BL417 Geological Sciences Phase 2 F100 IGWS East
(F100) Lab Renovations
IU 20250361

ADDENDUM NO. 3
14217

Addendum #3

RE: Indiana University
BL417 GEOLOGICAL
SCIENCES - FACULTY
100 - GEOLOGICAL
SCIENCES

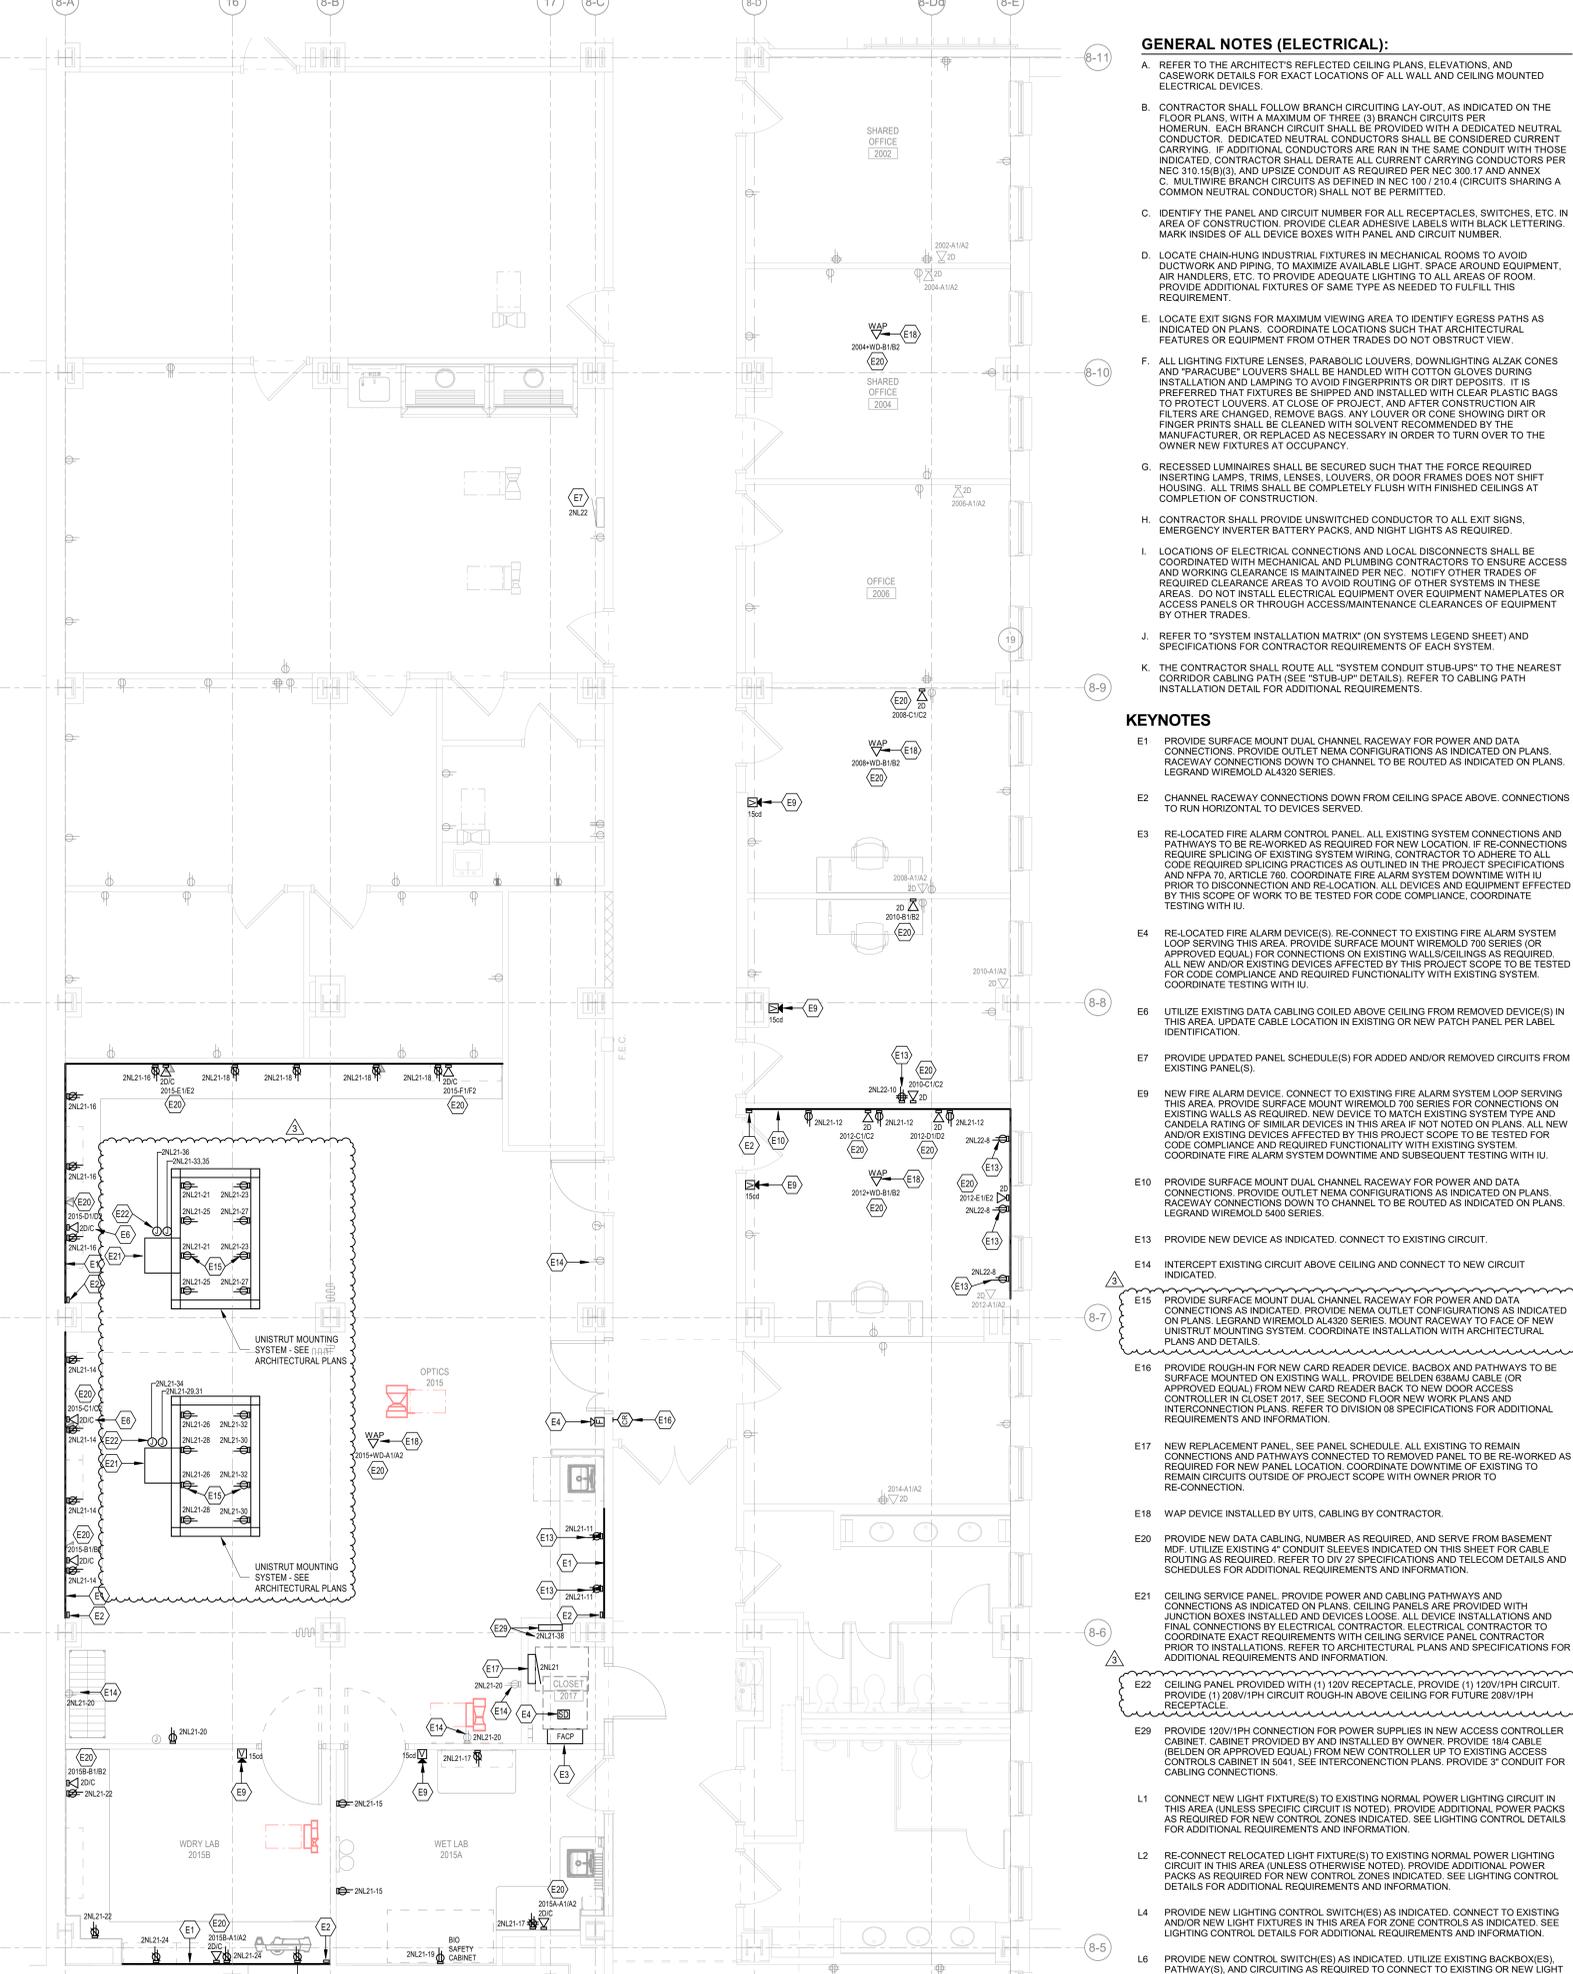
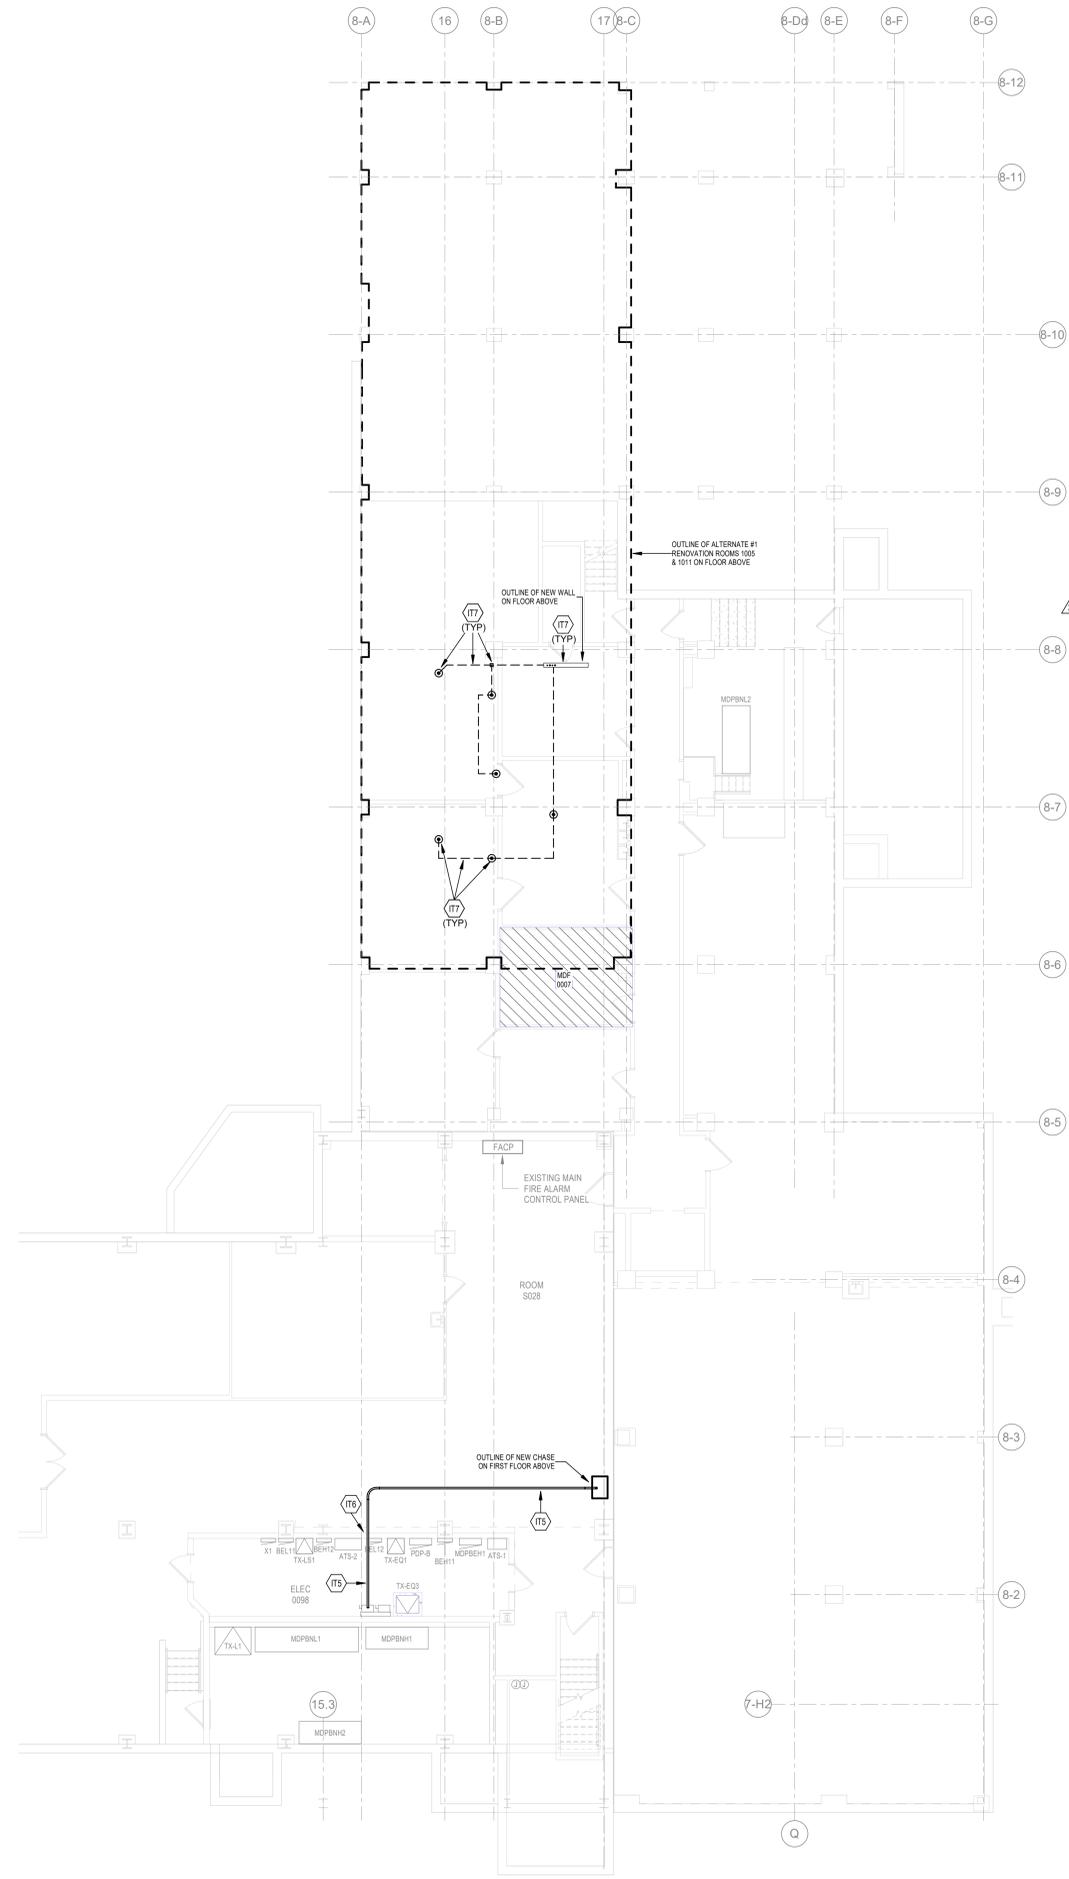
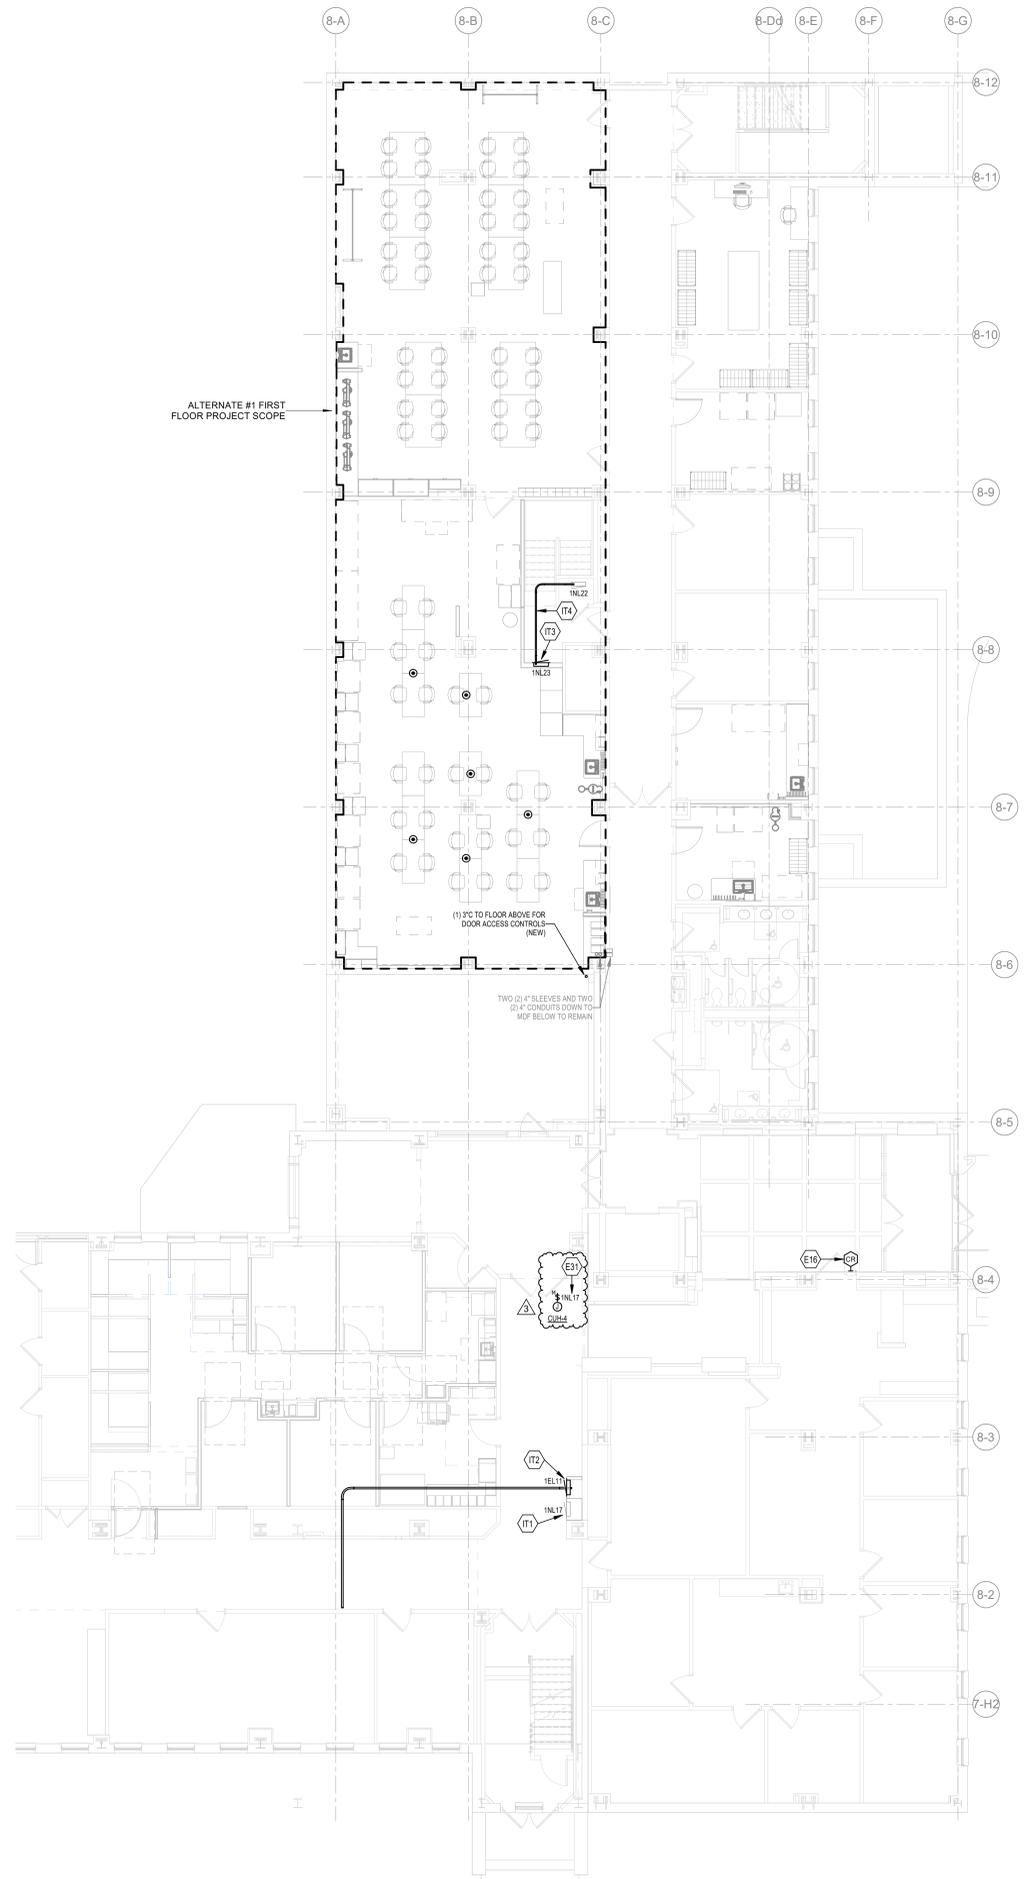
7. Sheet E100 – ELECTRICAL LEGEND & GENERAL NOTES
 - a. Equipment schedule added to sheet.
8. Sheet E202 – SECOND FLOOR - EAST WING - ELECTRICAL PLANS
 - a. Revised scope for Unistrut mounting system.

- b. Revised tagged notes #15 and #E22.
9. Sheet E300 – PARTIAL INTERCONNECTION PLANS - BASEMENT & FIRST FLOOR
 - a. Added connection for cabinet heater.
